NRA presentation

C-1 Authorization process

Regulatory process under the Reactor Regulation Act

IAEA Regulatory Review Mission on ALPS Treated Water Handling
23 March 2022

Homogenization of Radioactivity of ALPS Treated Water in Tanks Prior to Discharge into the Sea

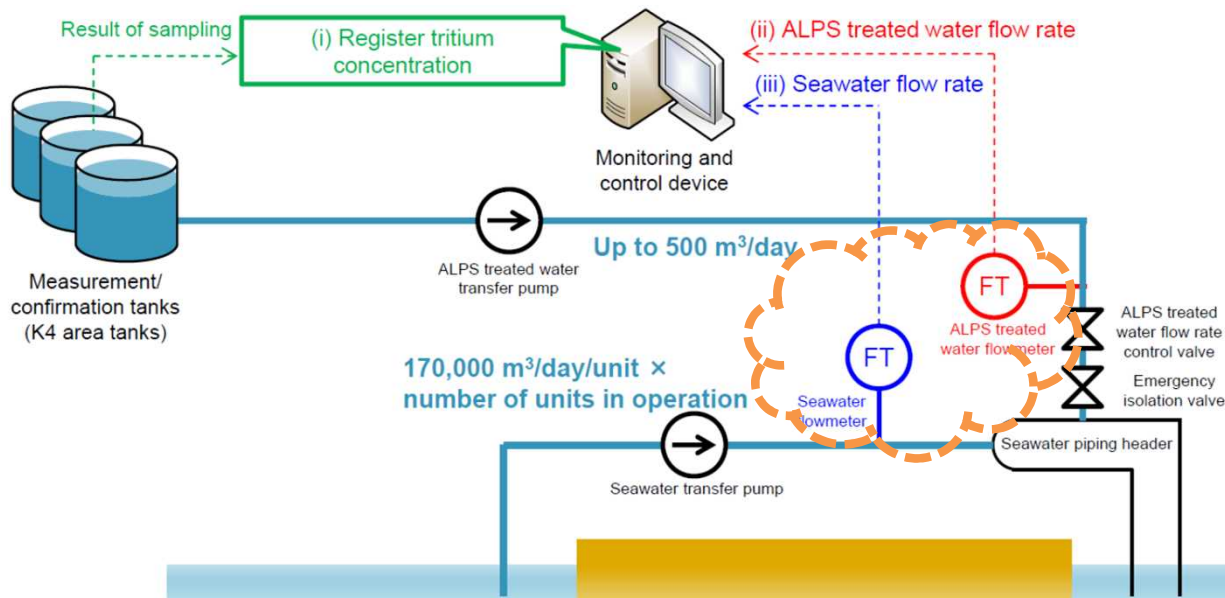
- **Whether precipitated radioactive material is present** in ALPS treated water; in that case the effects of the water remaining in the tanks after discharge

- With tritium concentration analyzed after circulation and agitation test, **homogenization was confirmed.**
- **The other nuclides contained in ALPS treated water are in ionized state**, thus they move in the same manner as tritium.

Method and evaluation of mixing of ALPS treated water with seawater

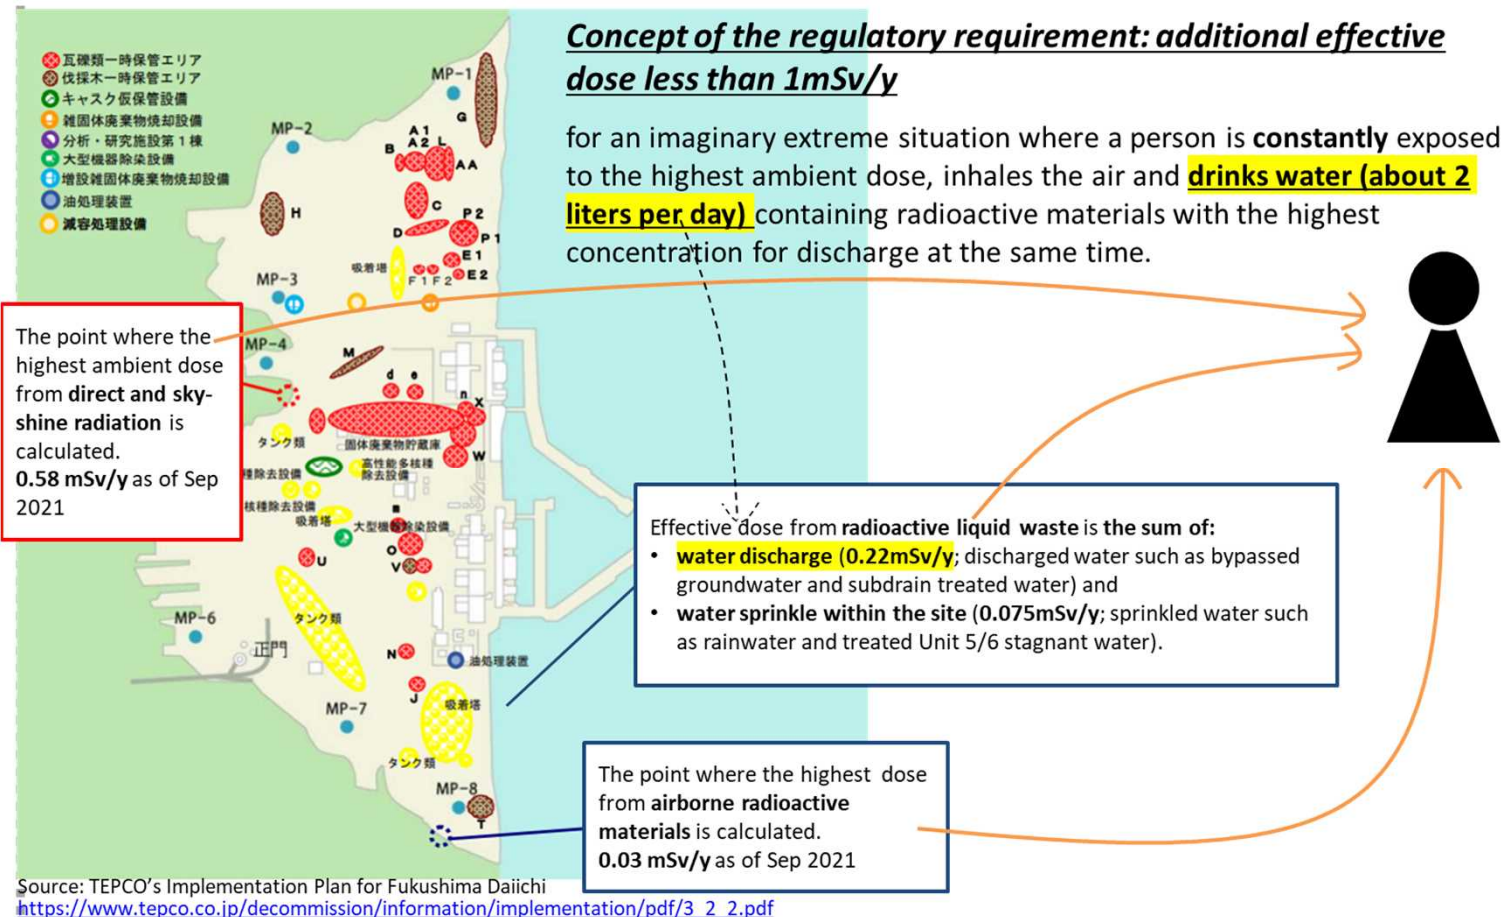
- Design concept and **reliability of flow measurement**
- **Expected measurement errors** of ALPS treated water flowmeter as well as the seawater flowmeter
- In the simulation, the criteria to judge that the concentration is more or less below 1500 Bq/L and also the position to meet the criteria

- **ALPS treated water flowmeter is to be duplicated.**
- Correction for measurement errors, i.e., plus correction for analytical error, plus correction for ALPS treated water flowmeter and minus correction for seawater flowmeter.
- Limit the concentration of tritium up to 1E+6Bq/L as the most conservative case for simulation
- Simulation to be redone based on the updated design

- Pending the result of simulation based on the updated design of the seawater pipe header and the following pipe.

Design considerations for natural phenomena

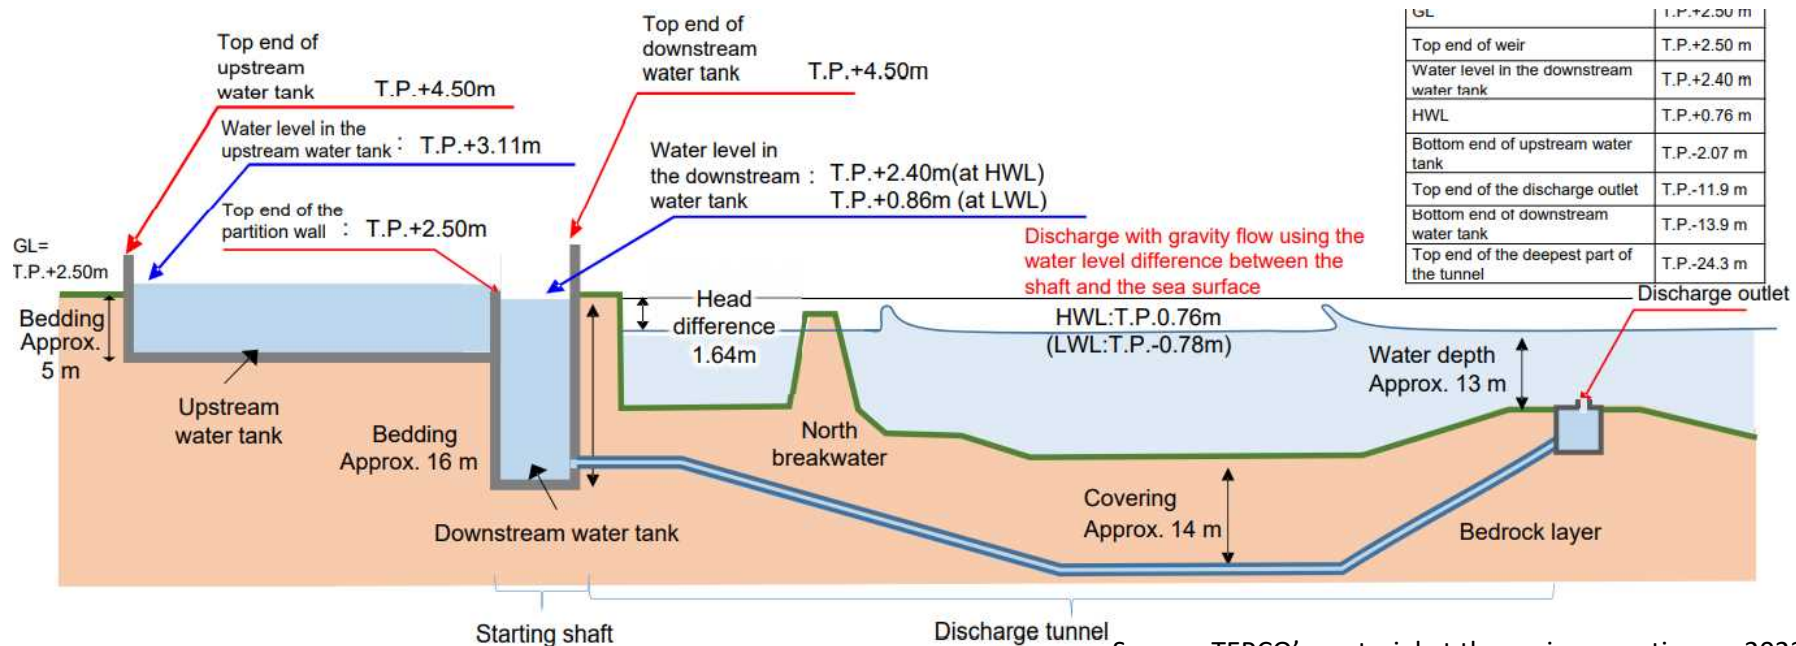
- For each structure, system, and component, safety function and the impact of the loss of safety function
- Measures against natural hazards such as earthquake and tsunami as well as external human-induced events, **taking into account the potential radiological impact**

- **The potential impact is assessed to be $<1\mu\text{Sv}$** assuming the shielding of K4 tanks is lost and ALPS treated water leaked into the weir is evaporated until salvage, thus **Class C**.
- Against potential leakage, the weir around K4 tanks is constructed as Class B.
- Countermeasures to prevent or mitigate the impact of leakage expansion are established.

Seismic ground motion to be applied to Class C is static ground motion 1.0 Ci (0.2 G).

Design considerations for reliability

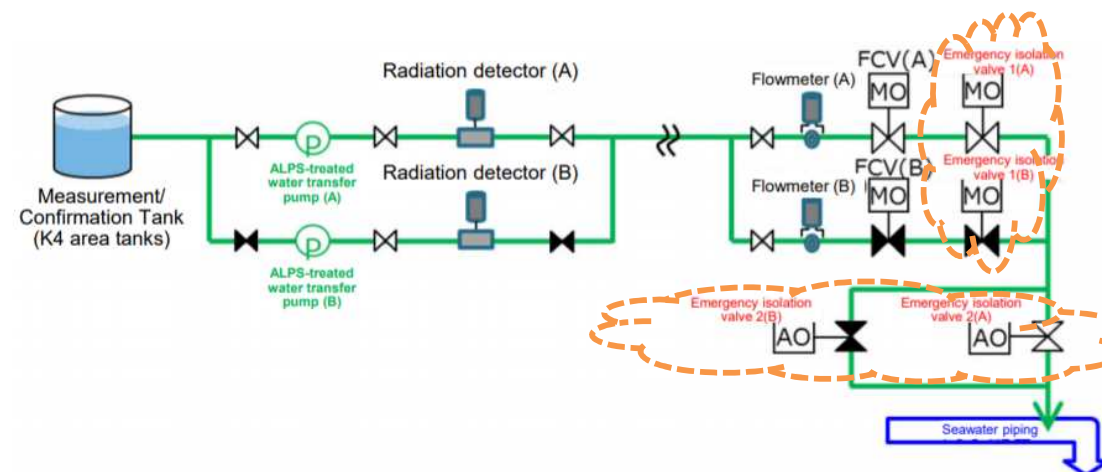
- Operation and procedures of stopping discharge in each case of closing the emergency isolation valves or otherwise and
- Criterion to judge unusual situations considering the fluctuation between the duplicated ALPS treated water flowmeters, provided unusual situation is detected by the difference in the indicated values of both flowmeters.

- Valves among 3 Measurement/confirmation tank groups are **set dual-redundantly in series**.
- ALPS treated water flowmeter to monitor dilution rate is **set dual-redundantly by doubling differential pressure detector and signal transmission system**.
- Emergency isolation valve is **set redundantly for closing function and diversely for driving source**, and both valves are fail-safe design in case of the loss of external power supply.

Evaluation method based on Master Logic Diagram

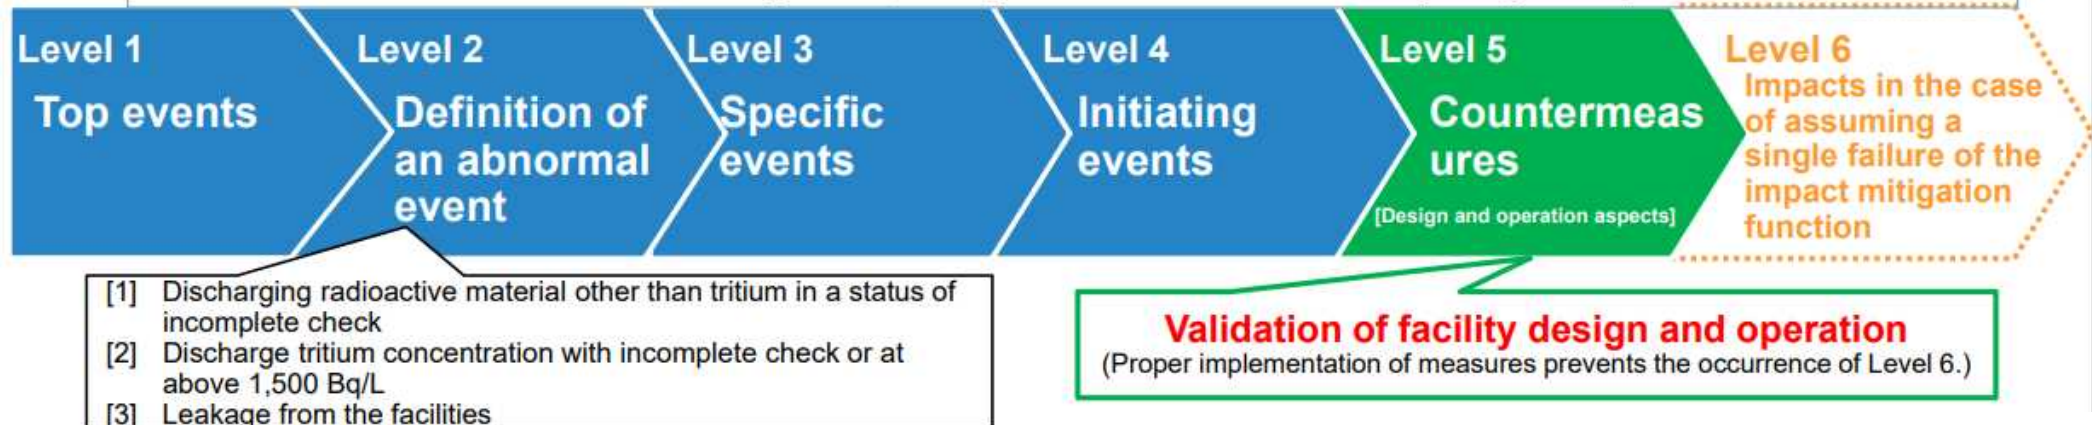
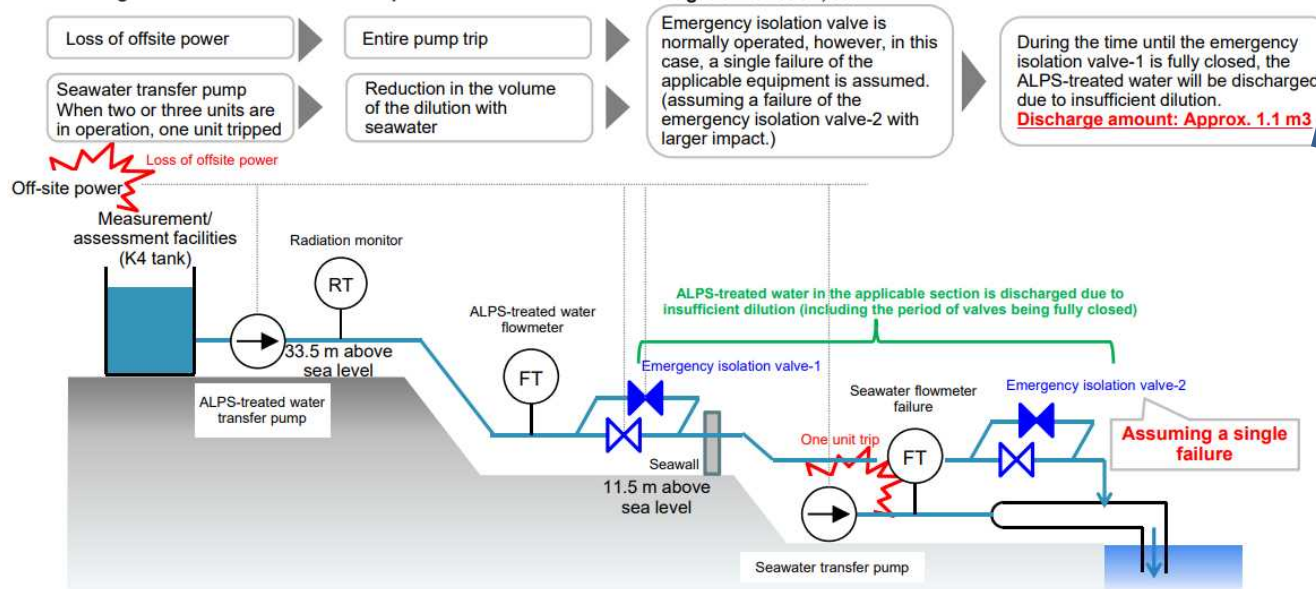
- Assumed unusual occurrences including component failure
- Equipment, human resources and procedures necessary for dealing with the said event
- **Amount of the unintended discharge**
- Assumption of a single failure of the component that leads to the severest result

- **Failure of passive devices** such as leaks due to piping thinning or defective connection

- Specifications and driving sources of **emergency isolation valves**
- Amount of leakage into the weir in the event of a failure of passive equipment

- **Master Logic Diagram (MLD)** is used to identify unusual occurrences.

- **Need of redundancy for ALPS-treated water flowmeter**
- 2 initiating events linked to the 1 same abnormal event “Discharge tritium concentration with incomplete check or at 1,500 Bq/L or above”.
- **Approximately 1.2m³ of unintended discharge**; greatly smaller than the planned discharge amount per day (up to 500m³/day).

Updated to 1.2m³ at the review meeting on March 18 after scrutinizing the reaction time of emergency isolation valve 1
